HISTORIC AND DESIGN REVIEW COMMISSION

June 03, 2020

HDRC CASE NO: 2020-229
ADDRESS: 305 BURLESON ST
LEGAL DESCRIPTION: NCB 512 BLK 25 LOT E 47.68 OF W 104.15 OF S 13.9 OF 7 & E 47.68 OF W 104.15 FT OF 8
ZONING: R-4, H
CITY COUNCIL DIST.: 2
DISTRICT: Dignowity Hill Historic District
APPLICANT: Dianet Daniel
OWNER: Robert Prado/Delafield Investments, LLC
TYPE OF WORK: Window and door modifications, rear deck
APPLICATION RECEIVED: May 07, 2020
60-DAY REVIEW: Not applicable due to City Council Emergency Orders
CASE MANAGER: Edward Hall

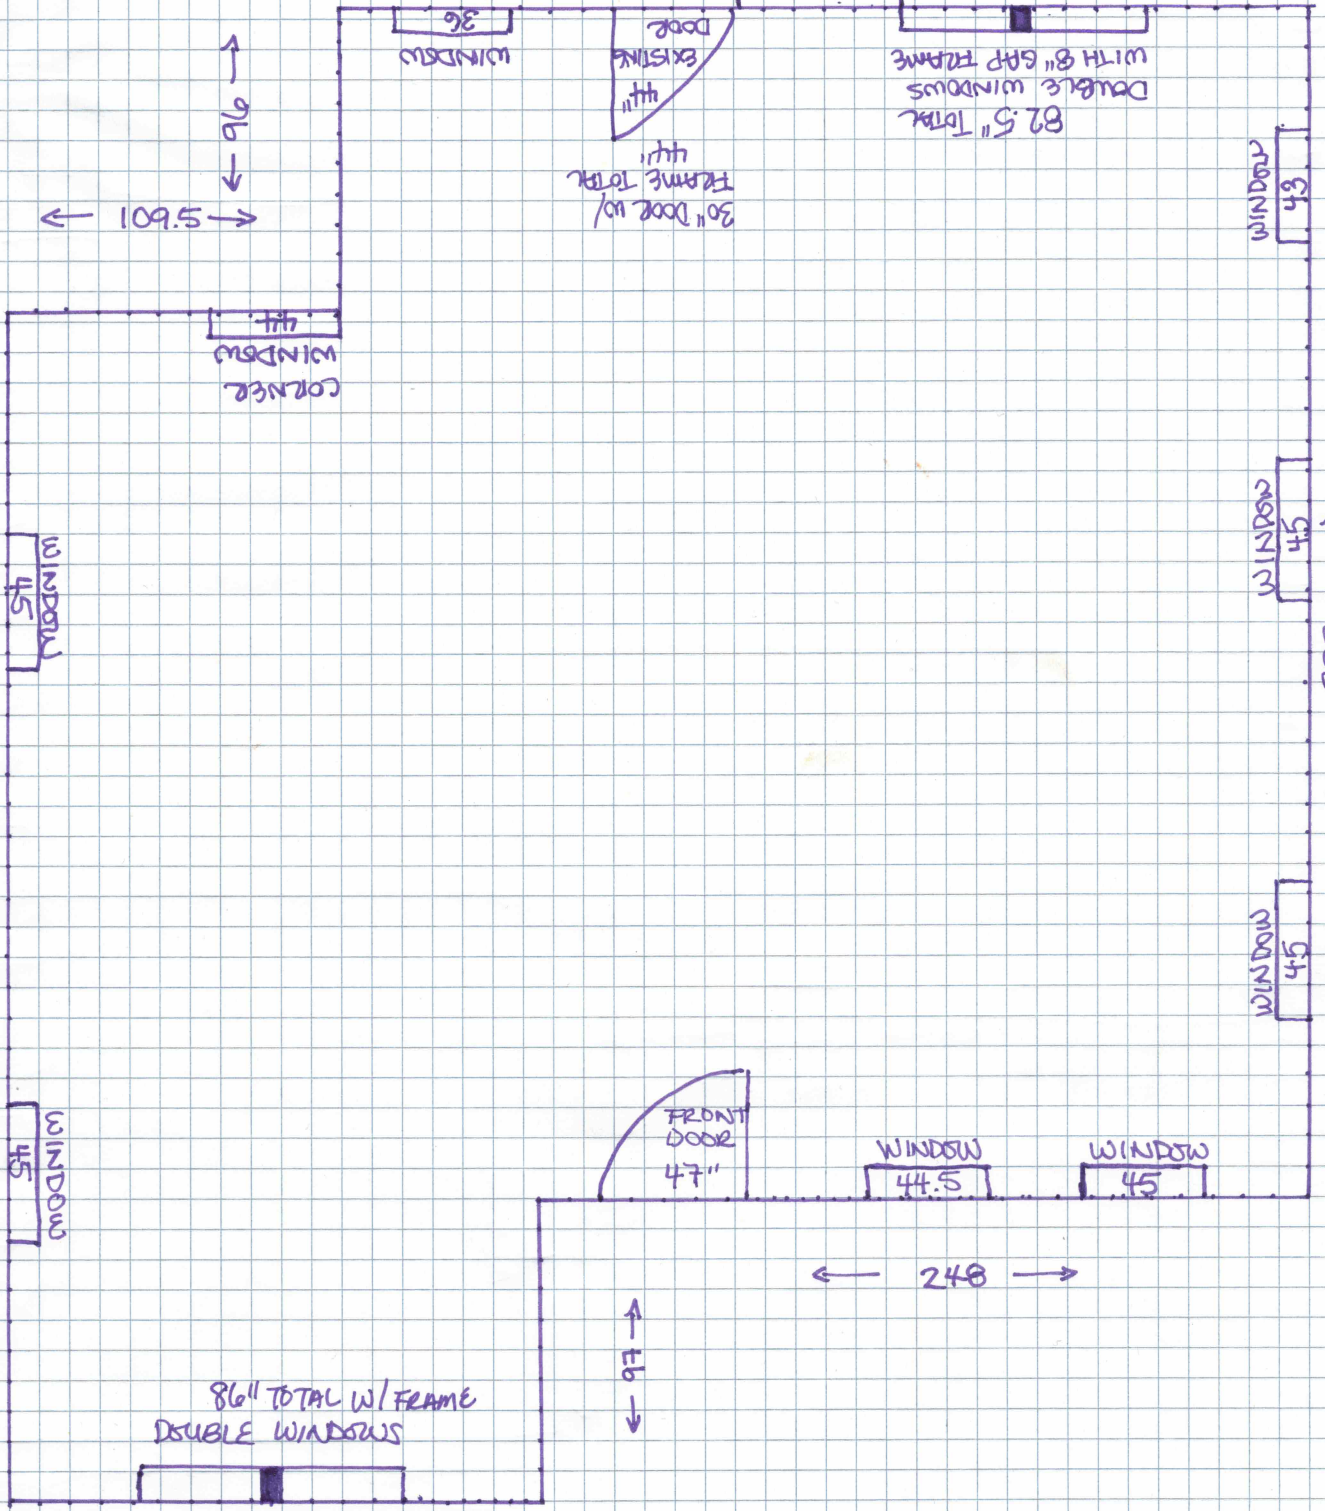
Counter length window in kitchen

NEW
DOOR

WALKOUT DECK

REMOVE

Existing door, requesting to relocate

PROPOSED ELEVATION DRAWING

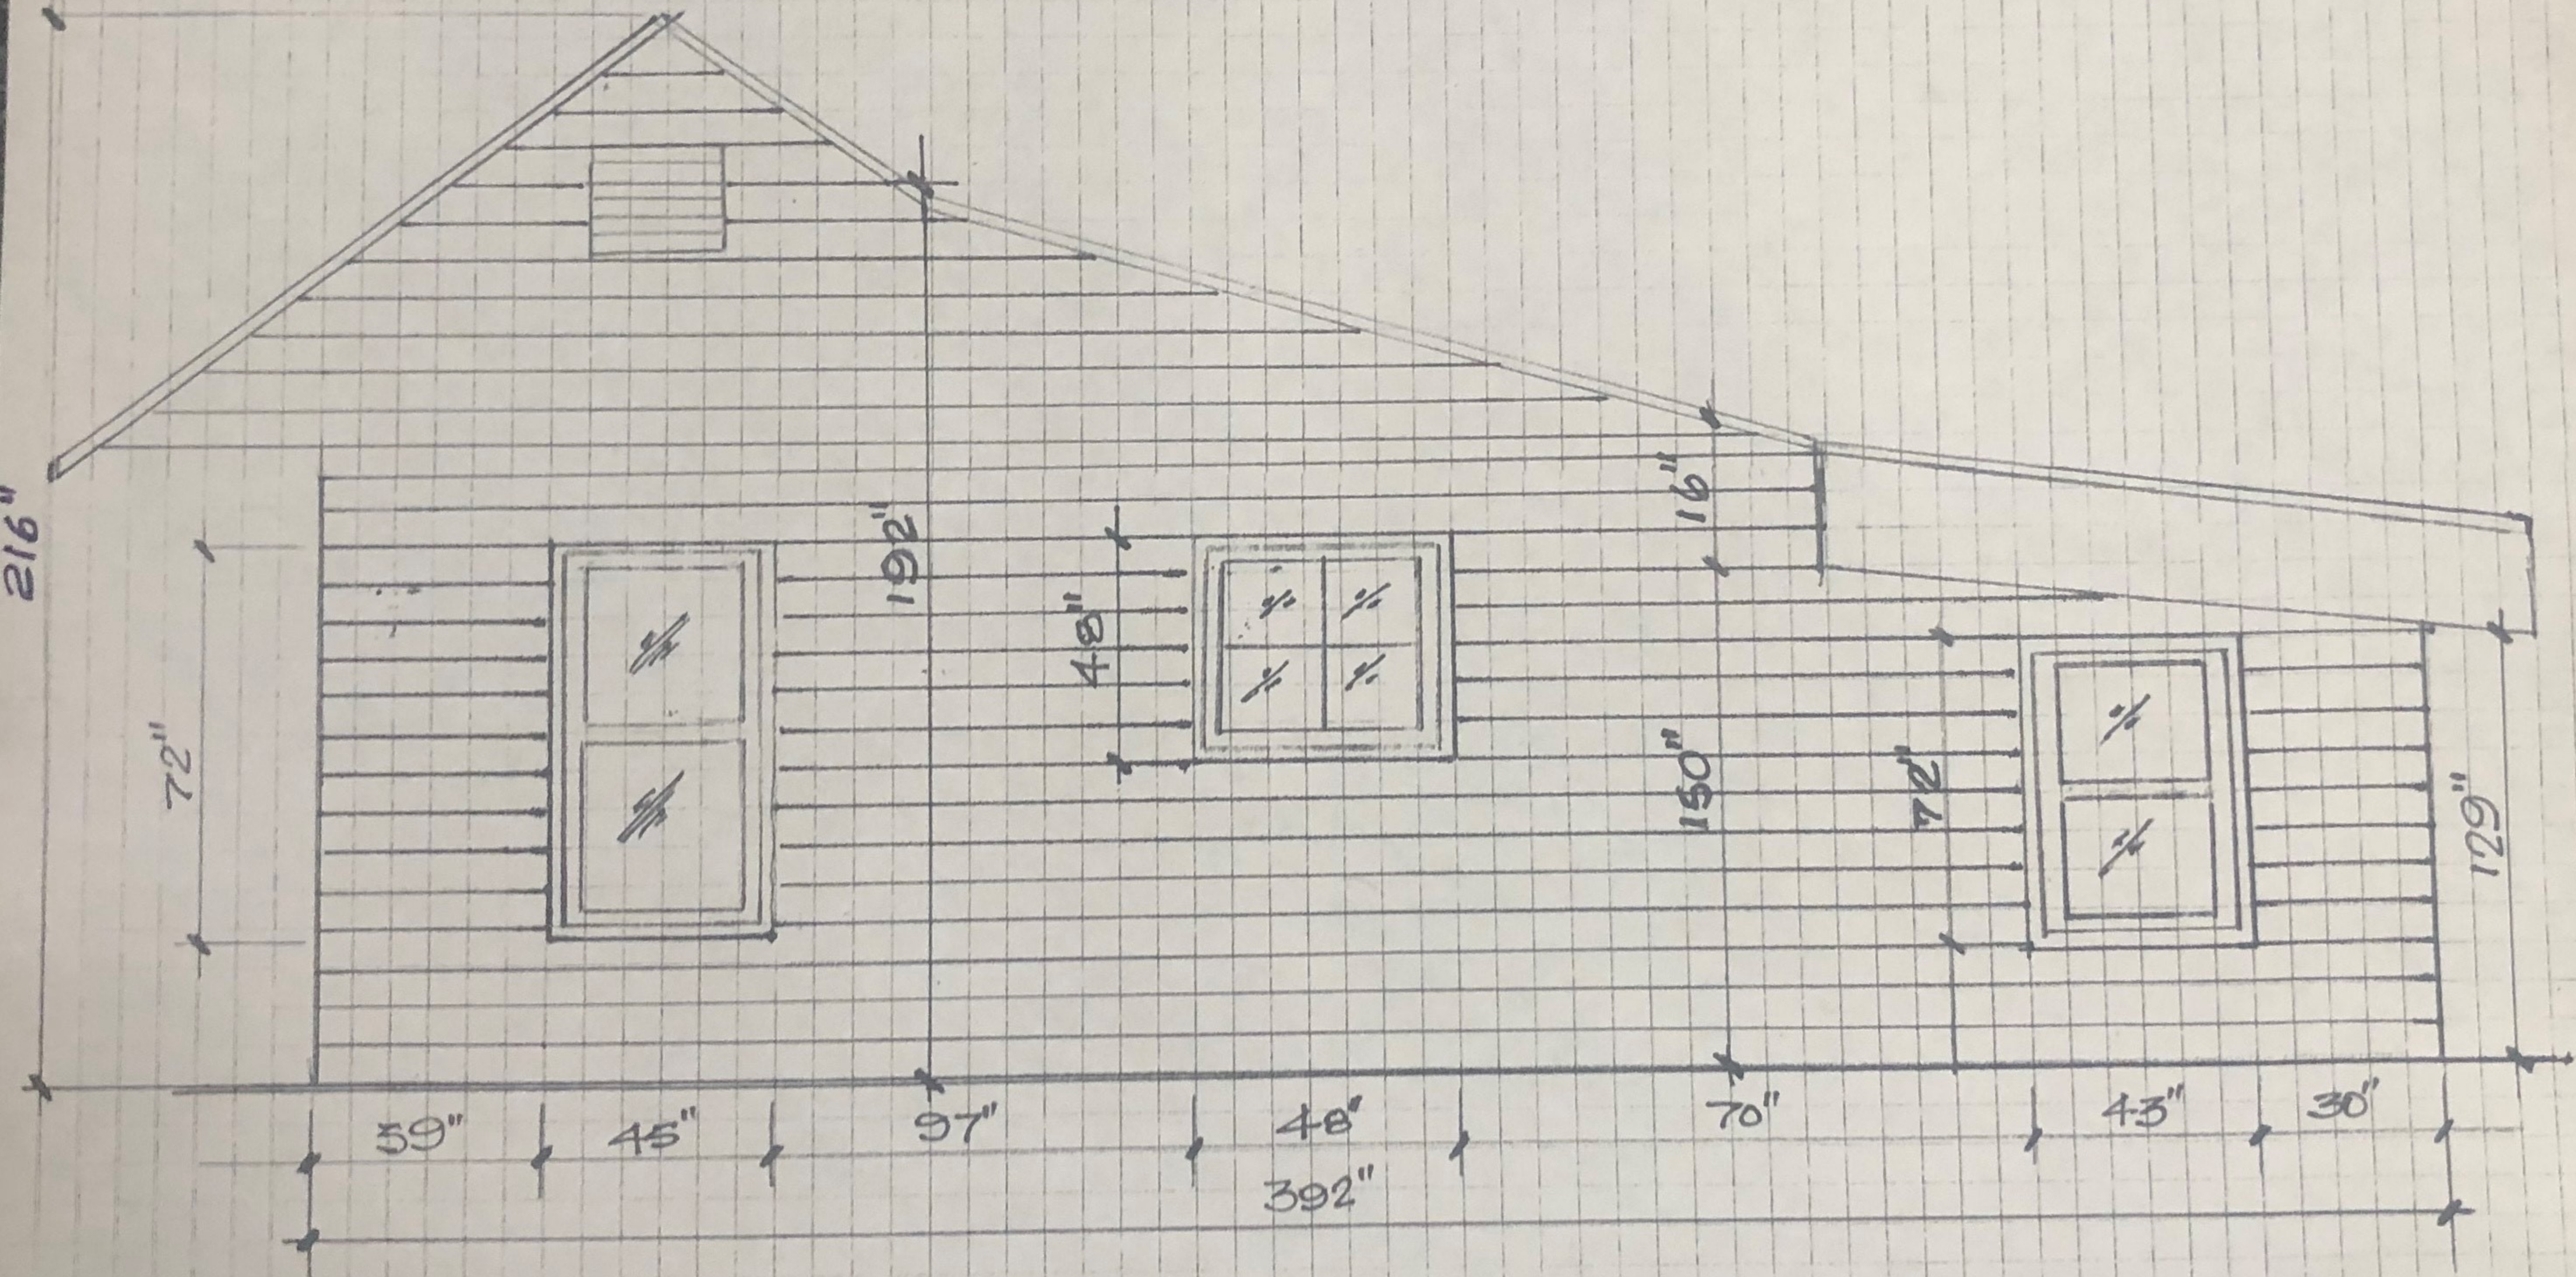
- RELOCATING BACK DOOR
- DEMO OF UTILITY CLOSET
- REMOVING ONE WINDOW

- b. REAR PATIO – The applicant has proposed to construct a rear patio deck to be attached to the historic structure. Generally, staff finds the location of the rear deck to be appropriate; however staff finds that the rear deck should feature an offset from the historic structure’s side wall plane.

- c. REAR FENESTRATION MODIFICATIONS – The applicant has proposed to eliminate a rear facing window and shift a rear door in an existing addition. The original window at this location no longer exists. Given that the applicant has proposed these modifications to a rear addition, staff finds them to be appropriate.

- i. That the proposed rear deck be inset from the historic structure’s wall plane.
- ii. That the proposed side window modification result in no modification to the width and head height of the window opening, and that the replacement window feature a one over one profile and be installed to match the existing windows, which feature installation depths comparable to an original wood window.

PROPOSED ELEVATION DRAWING

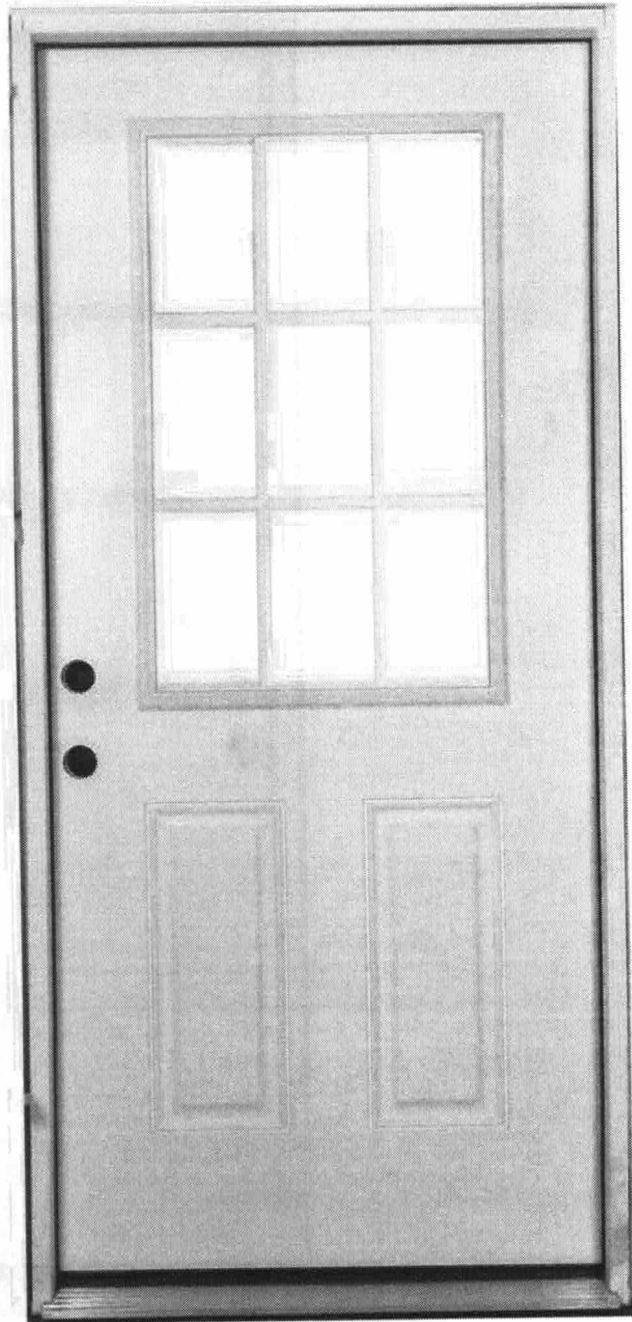
- MIDDLE WINDOW CHANGED FROM 45x72 TO 48x48 TO INCLUDE FRAME.

- d. SIDE WINDOW MODIFICATION – The applicant has proposed to modify the sill height from a full sized window to a half sized, non-original window on the side (East) façade of an existing addition. Staff finds the proposed request to be appropriate given its location in an addition; however, staff finds that the replacement window should feature a one over one profile. A non-wood window may be appropriate provided it features a profile and installation depth that matches the existing windows, which are installed comparable to an original wood window. Additionally, staff finds that the width and head height of the window should remain the same.
